ALERT TELEX

No. 31A005 R1

AIRCRAFT: EC 155 Civil Versions: B-B1.

SUBJECT: INDICATING AND RECORDING SYSTEMS
Landing Gear Extension Inoperative

FIGURE 1

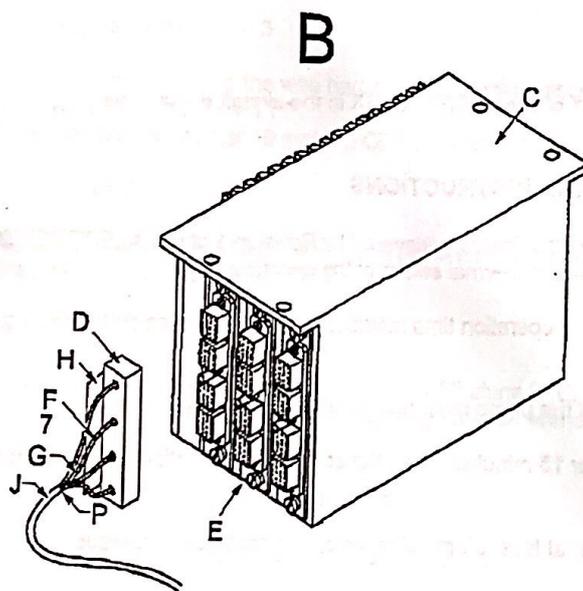
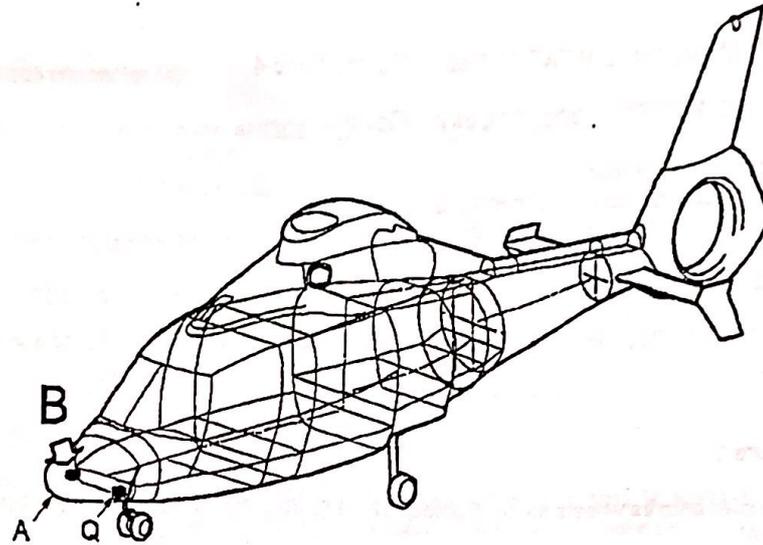
- Open radome (A) to gain access as per Detail B to ancillary system unit 10 alpha (C), located on the right side of the helicopter, beneath the horizontal support member of electrical master box 4 alpha.

- Unplug connector 10 alpha 2 (D) from fixed connector 10 alpha 2 (E).
- Remove:
 - . Identification marker 10 alpha 2 CP1 and retain it.
 - . Cable clamp (F) that retains the harness and green protecting sheath (G) on clamping block (H), at the rear of connector 10 alpha 2 (D).
- Remove the cable clamps which retain the green protecting sheaths (G) and (J) to move the wires (their electrical markers are listed below) aft of connector 10 ALPHA 2 CP1 and to remove them from wire harness 10 alpha 2 CP1, at intersection (P) of protecting sheaths (G) and (J) (as per Figures 1 and 3).

- Plug connector 10 alpha 2 (D) into connector 10 alpha 2 (E).
- Secure/screw connector 10 alpha 2 (D) using an Allen wrench.

FIGURE 2

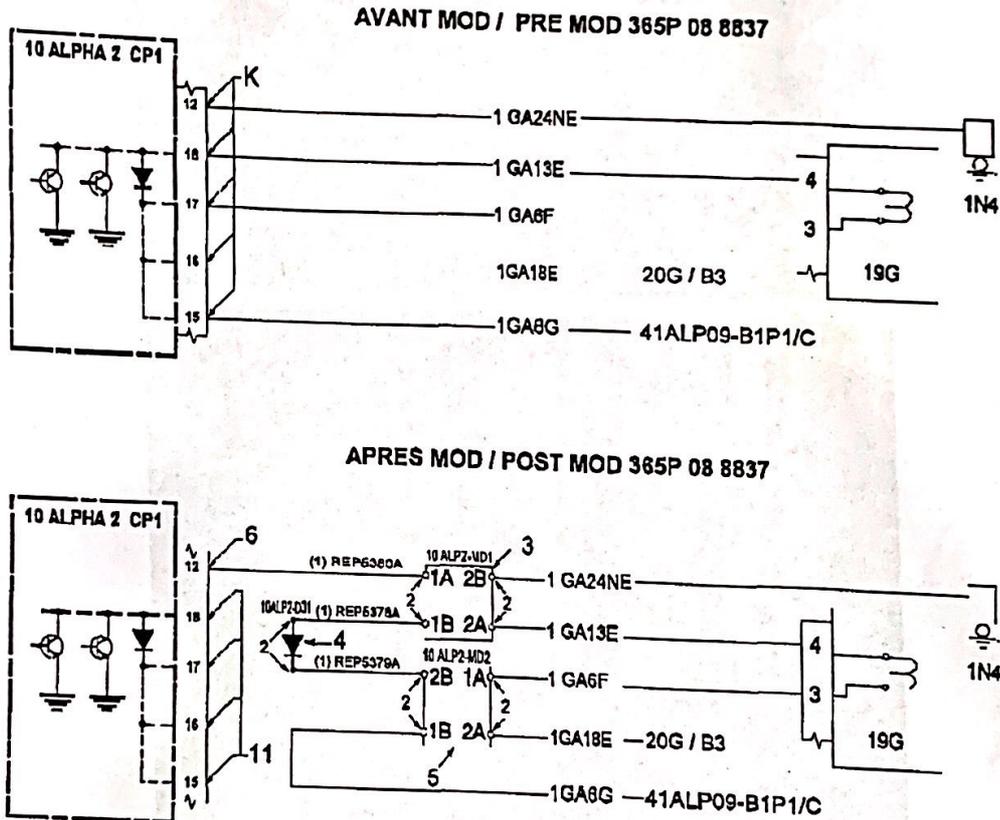
- Unplug the following wires from connector 10 alpha 2 CP 1:
 - . Wire 1GA24NE from terminal 12,
 - . Wire 1GA6G from terminal 15,
 - . Wire 1GA18E from terminal 16,
 - . Wire 1GA6F from terminal 17,
 - . Wire 1GA13E from terminal 18.

Remove and discard contacts (K). To this end, cut the five wires, listed above, as close as possible to contacts (K) so that these wires need not be replaced and can be re-connected to connector 10 alpha 2 CP1 when the future modification is embodied.

- Blank the ports of unequipped contacts 15, 16, 17 and 18 of connector 10 alpha 2 CP1 with blanking plugs (10).
- Take wire (1) and cut it into three 140 mm long pieces.
- Strip both ends of each wire (1).

- Connect wires: 1GA6F, 1GA6G, 1GA13E, 1GA18E, 1GA24NE, REP5378A, REP5379A
REP5380A.

FIGURE 3

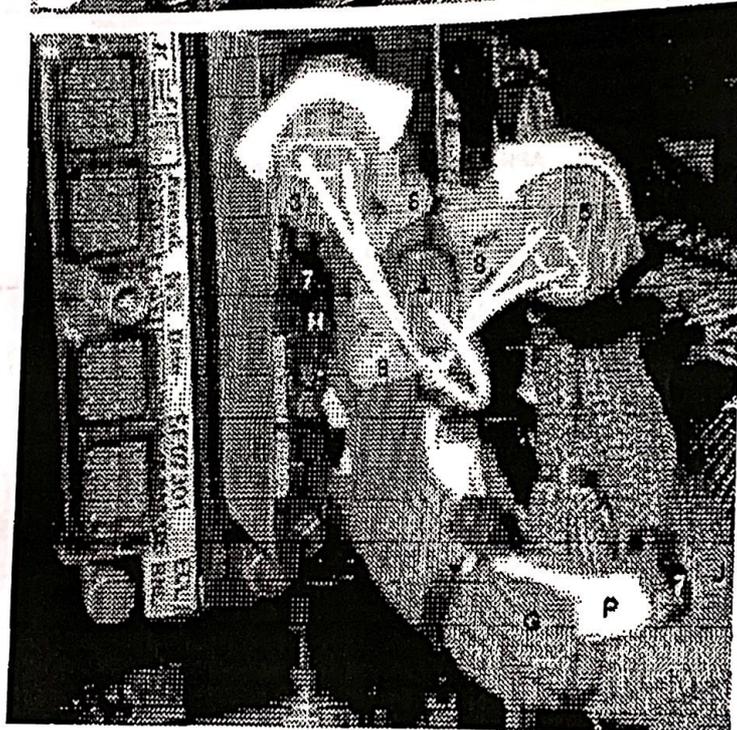
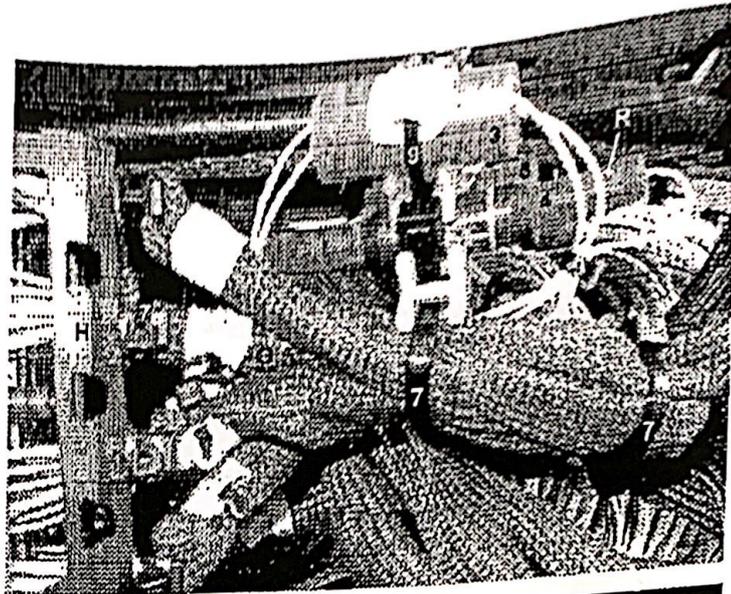
Before you make the connections of wires 1GA6F, 1GA6G, 1GA13E, 1GA18E and 1GA24NE in accordance with the procedure specified below, coil wire overlength from intersection (P) of protecting sheaths (G) and (J), and route these wires on protecting sheath (G).

The pictures on Figure 3 show the connection loops (R) of connectors (3) and (5), and of diode (4).

- REP5380A (1) terminal 1A
- REP5378A (1) terminal 1B
- 1GA13E terminal 2A
- 1GA24NE terminal 2B

- 1GA6F terminal 1A
- 1GA6G terminal 1B
- 1GA18E terminal 2A
- REP5379A (1) terminal 2B

- Diode connector (4):
 - Be careful to ensure the ANODE / CATHODE connections in accordance with the requirements.
 - REP5378A (1) ANODE,
 - REP5379A (1) CATHODE.
- Connector 10 alpha 2 CP1:
 - REP5380A (1) terminal 12.

- Correctly position protecting sheaths (G) and (J) on wire harness 10 alpha 2 CP1.
- Using clamps (7), hold sheaths (G) and (J) on the wires that make up harness 10 alpha 2 CP1.

- Attach connectors (3) and (5) and diode (4) to wire harness 10 alpha 2 CP1, using spacers (8) and clamps (7) and (9).

Location of the "LIMITATION" label

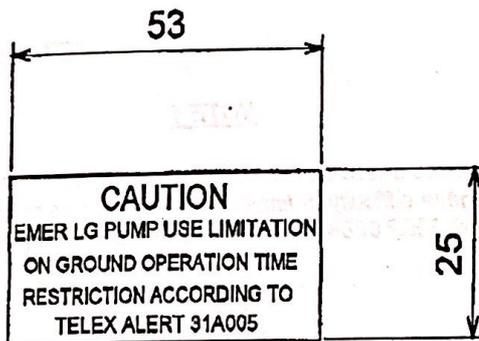
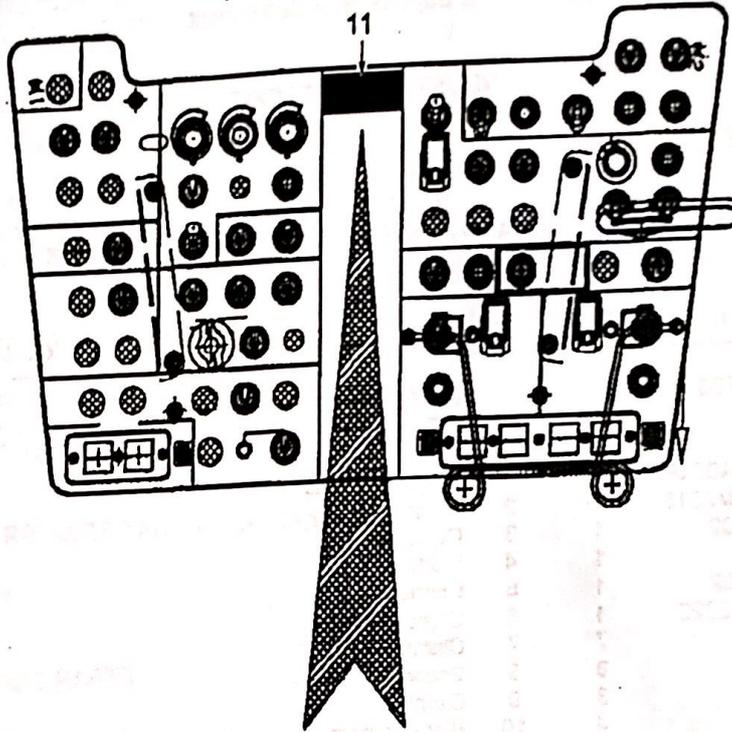
- Make a self-adhesive label:
 - . In accordance with required dimensions,
 - . text in white letters on red background.

- Affix the "LIMITATION" label (11) to overhead panel 12 alpha in the cockpit, as shown on Figure 4.

- 1) The continuous operation time of the pump must not exceed 10 minutes.
- 2) Allow the electric pump to cool for 15 minutes, when the continuous operation time of the pump is 1 to 5 minutes.
- 3) Allow the electric pump to cool for at least 30 minutes, when the continuous operation time of the pump is 5 to 10 minutes.
